## **SITE SUPPLEMENTAL INSTRUCTION**

**PROJECT:** Forestside Estates  
Attmar & Palleschi Drive  
Brampton, ON

**SITE SI NO.** M-9

**PURPOSE:** To revise P1 level communication mechanical layout.  
To clarify Building B 2<sup>nd</sup> floor board room F-23 location.

DRAWN	CHECKED	SCALE
MC	LM	1:150
DATE	PROJECT	DRAWING
MAY, 2019	<b>18-017</b>	<b>M-4</b>
		OF

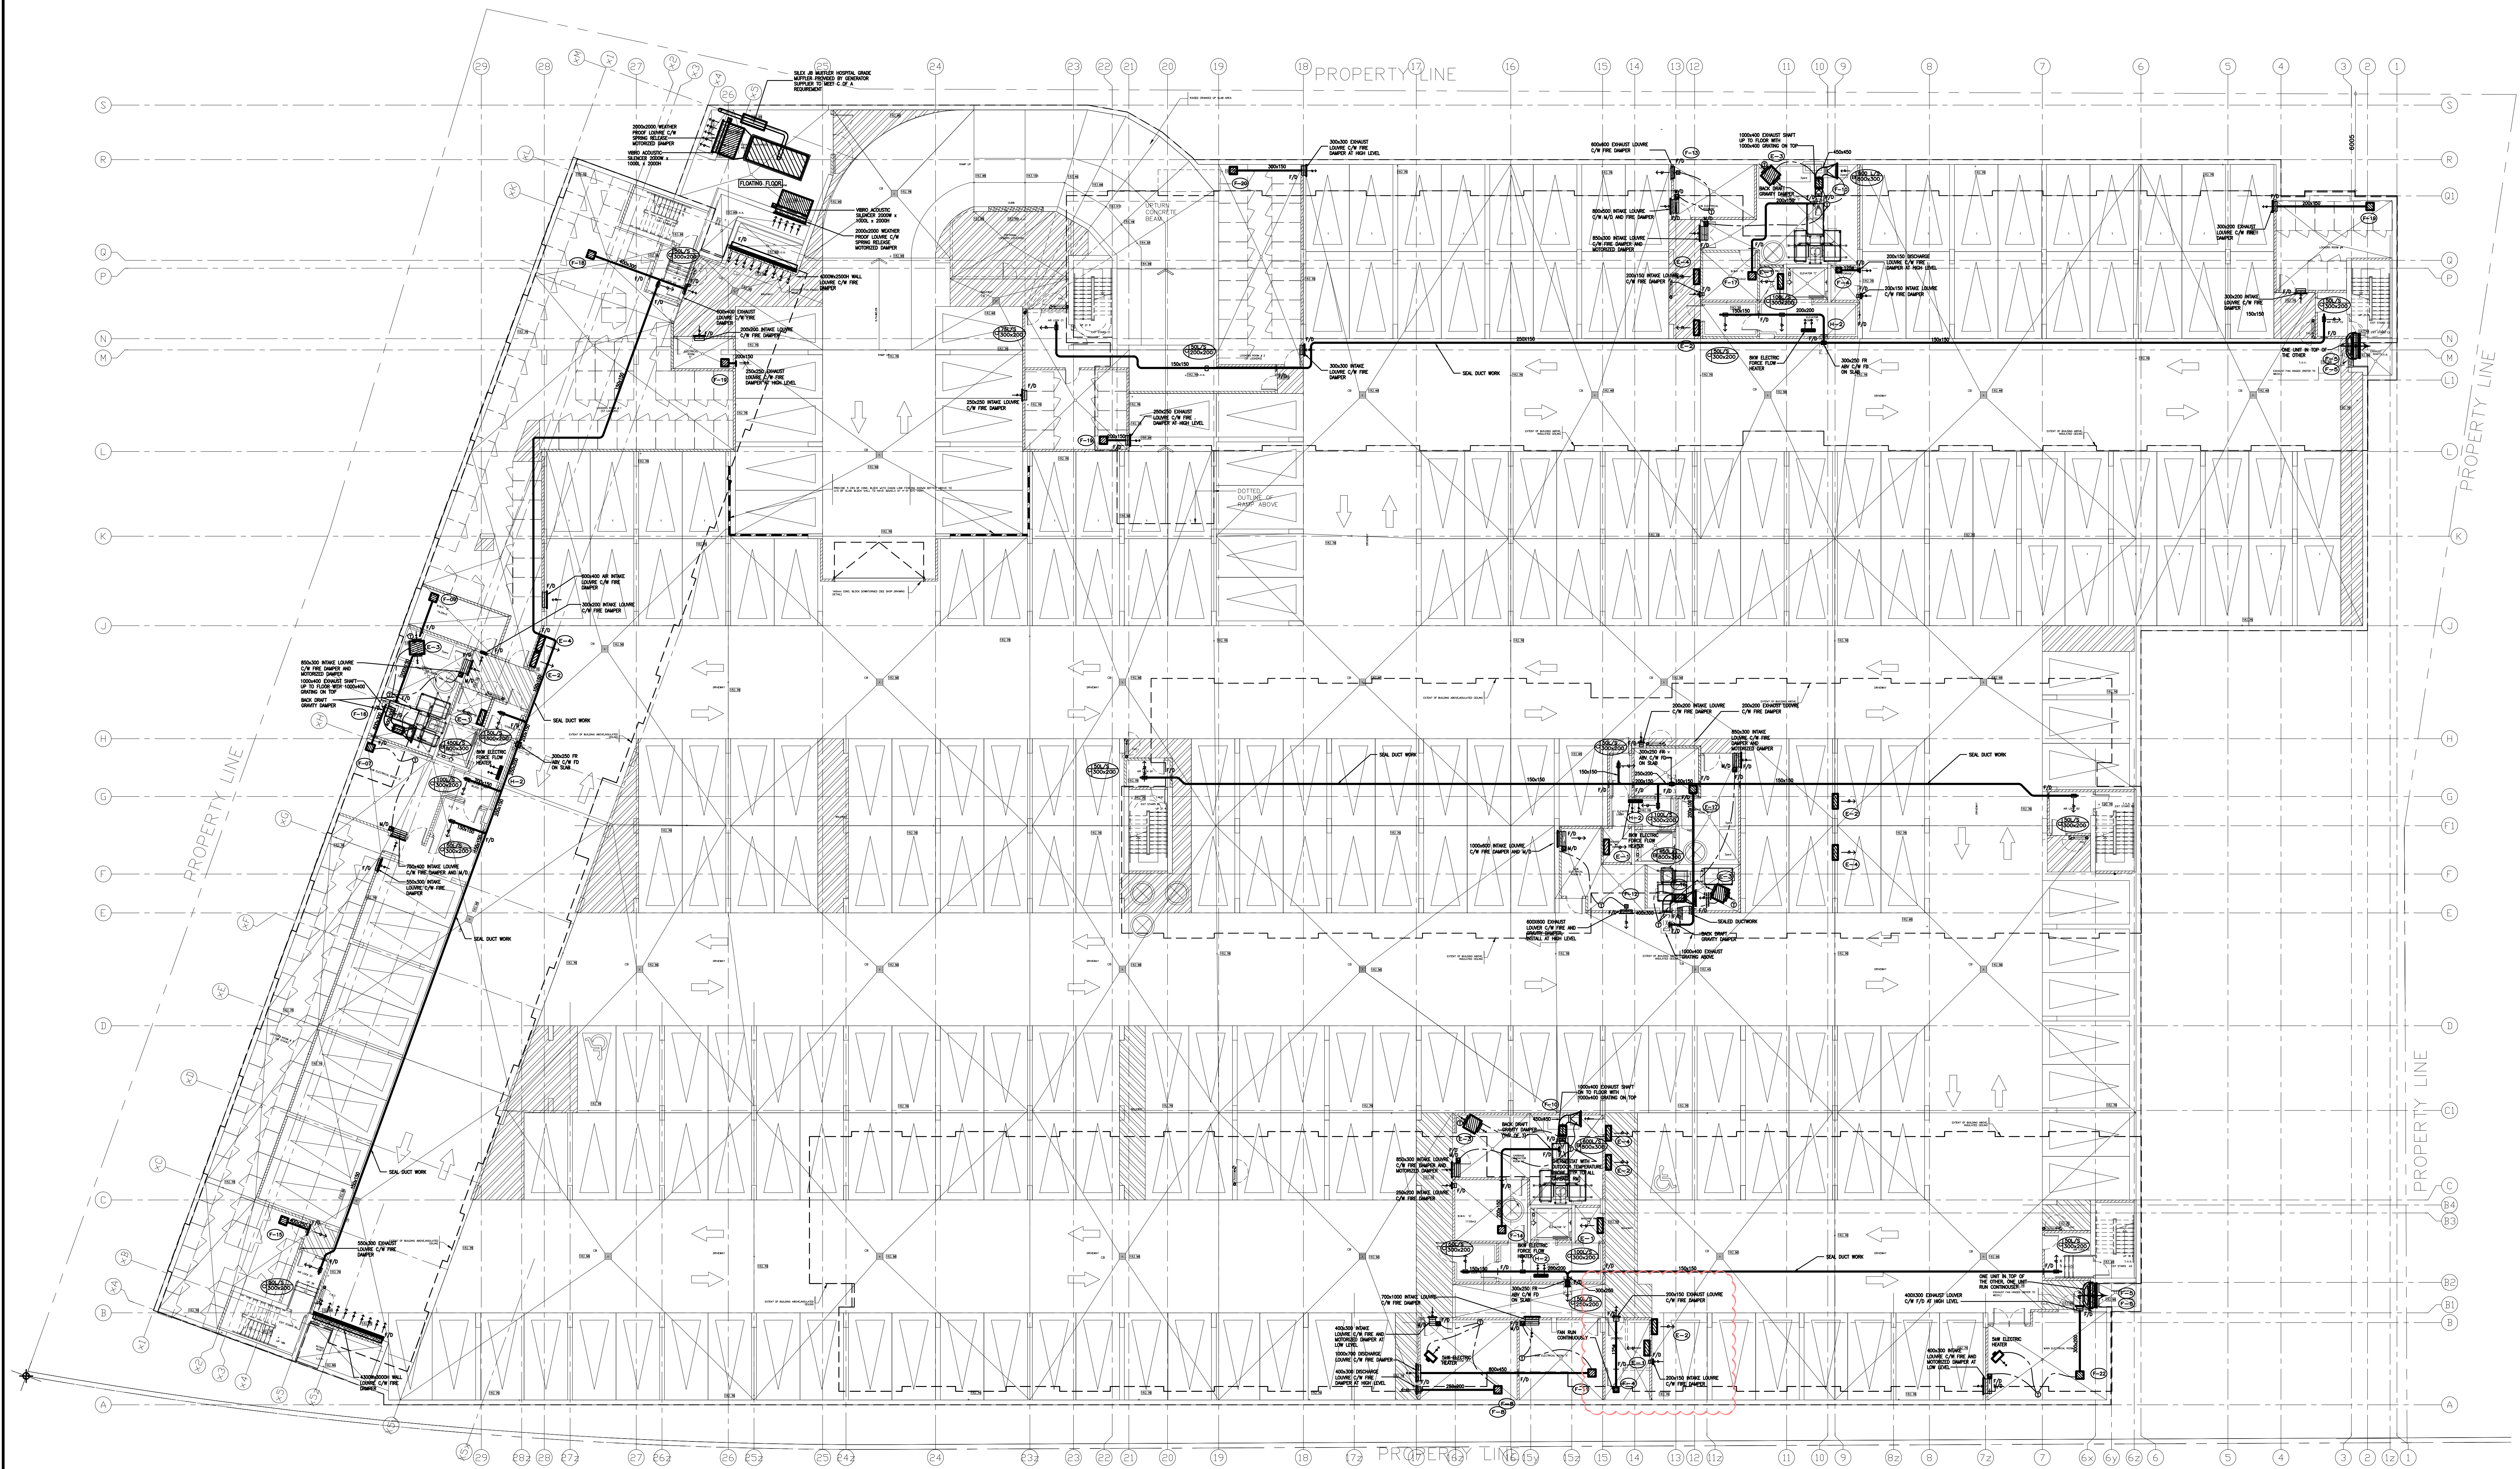
1.1 Deleted: One AC split unit E-1, E-2, one exhaust fan F-4 and one intake louver.

DRAWN MC	CHECKED LM	SCALE 1:50
DATE MAY, 2019	PROJECT <b>18-017</b>	DRAWING <b>M-27A</b> OF -

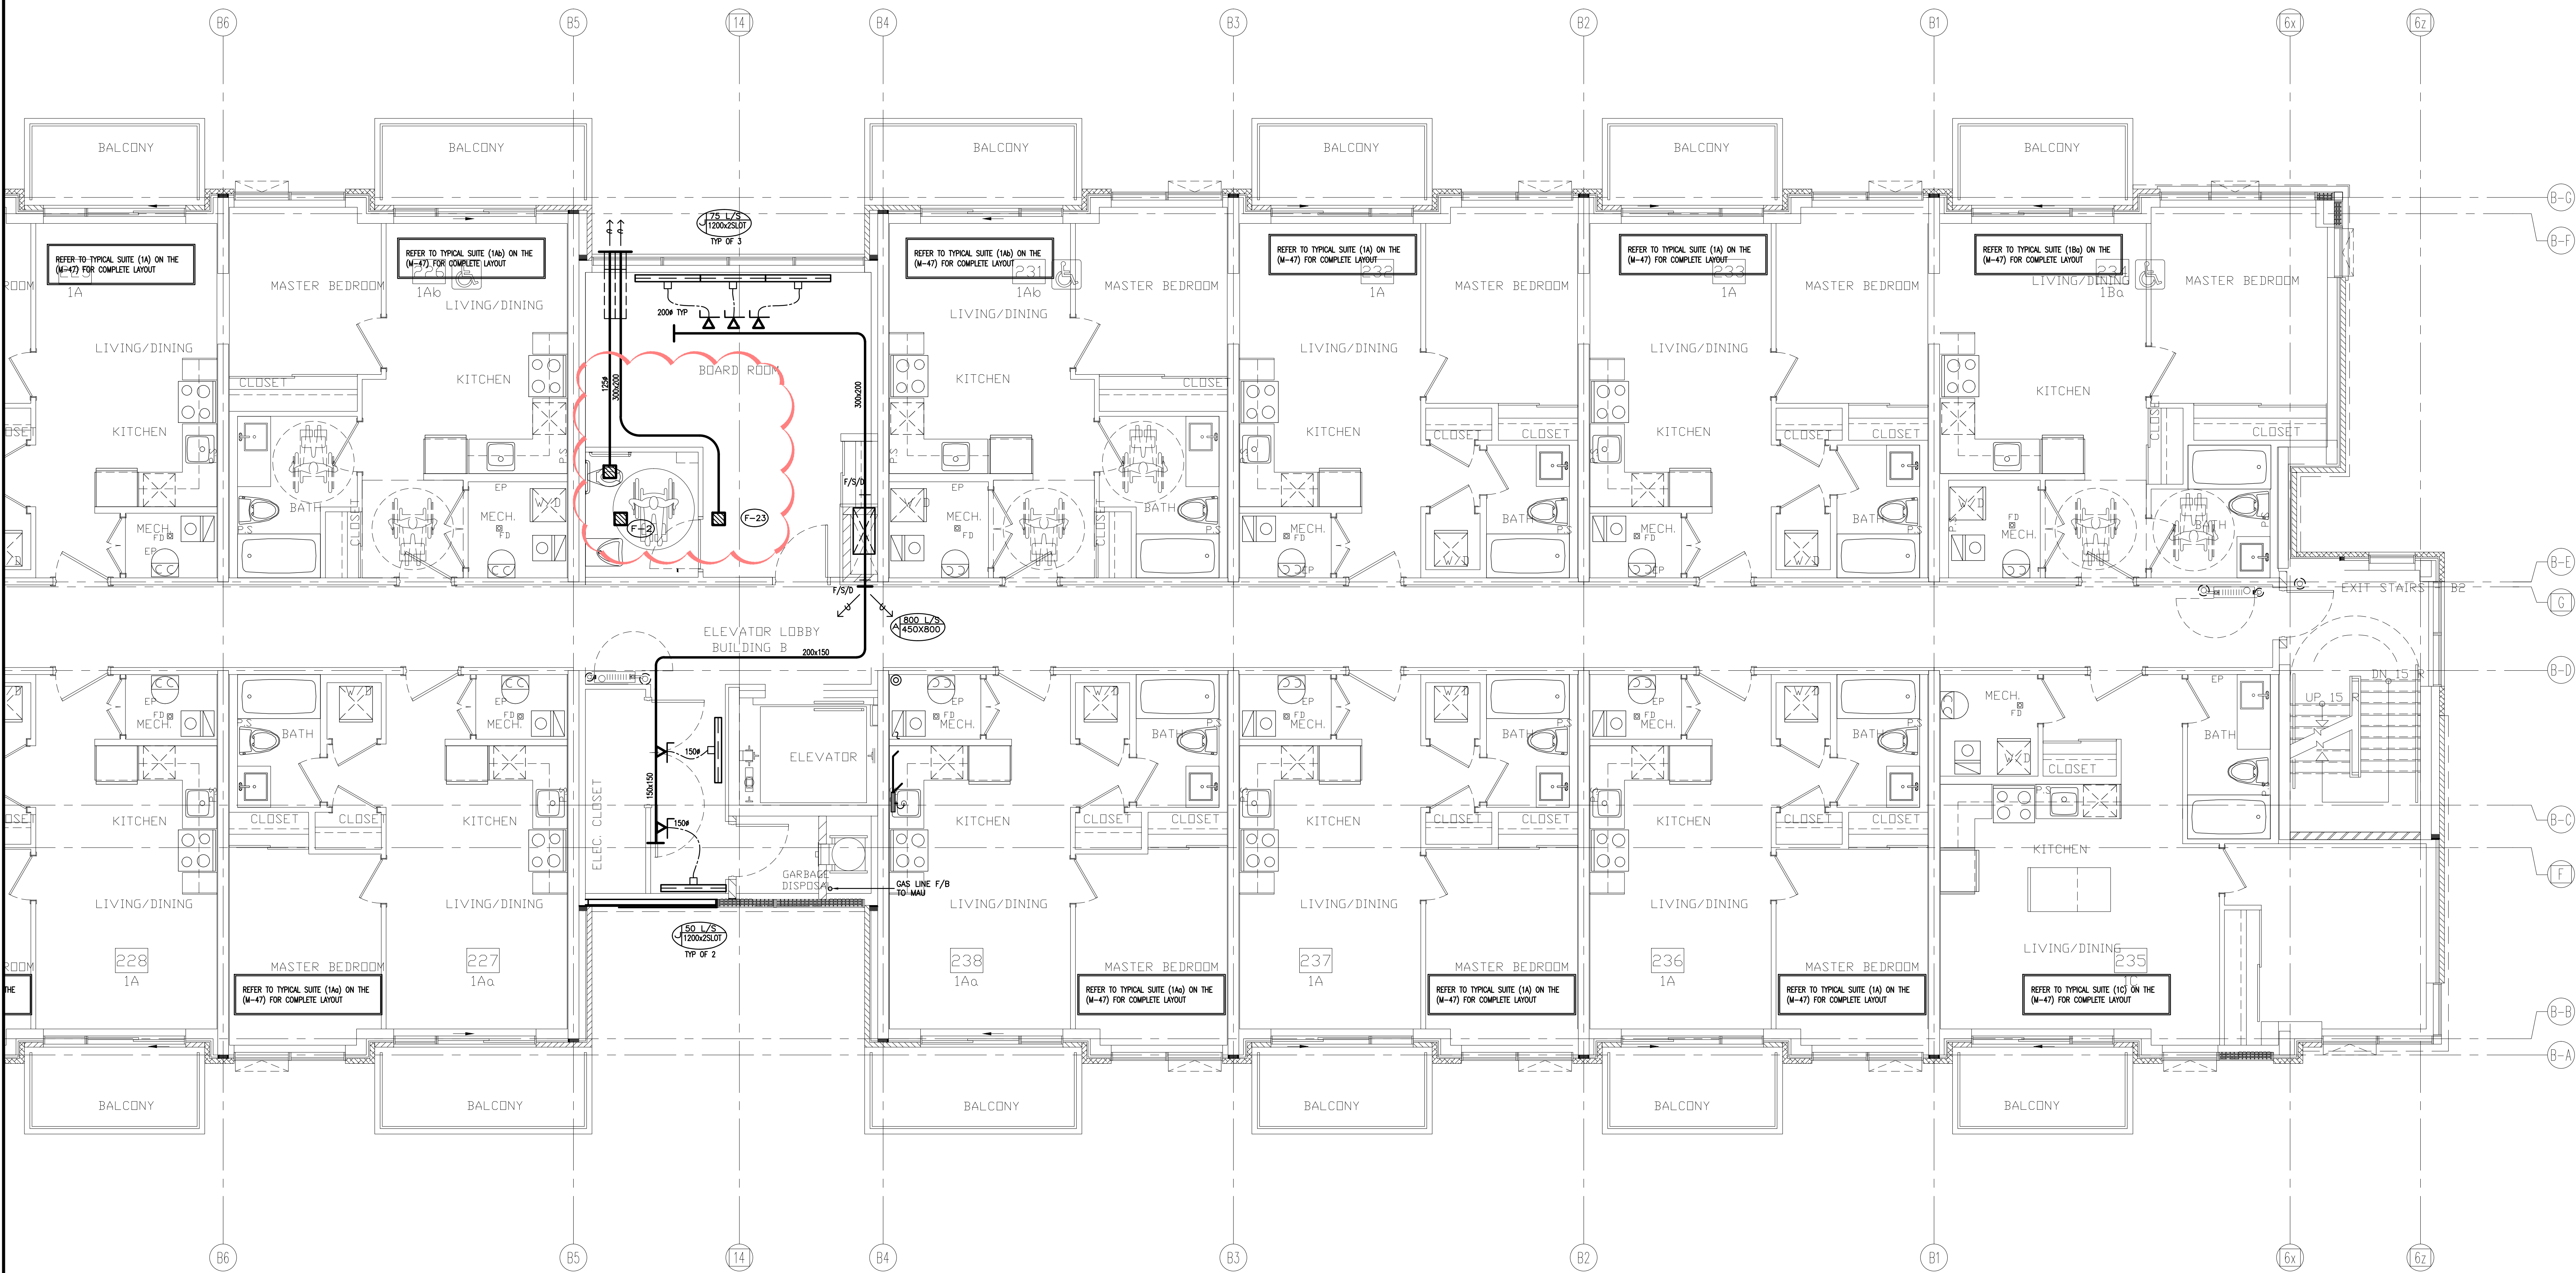
2.1 Relocated: Exhaust fan in boardroom at 2<sup>nd</sup> floor building B.
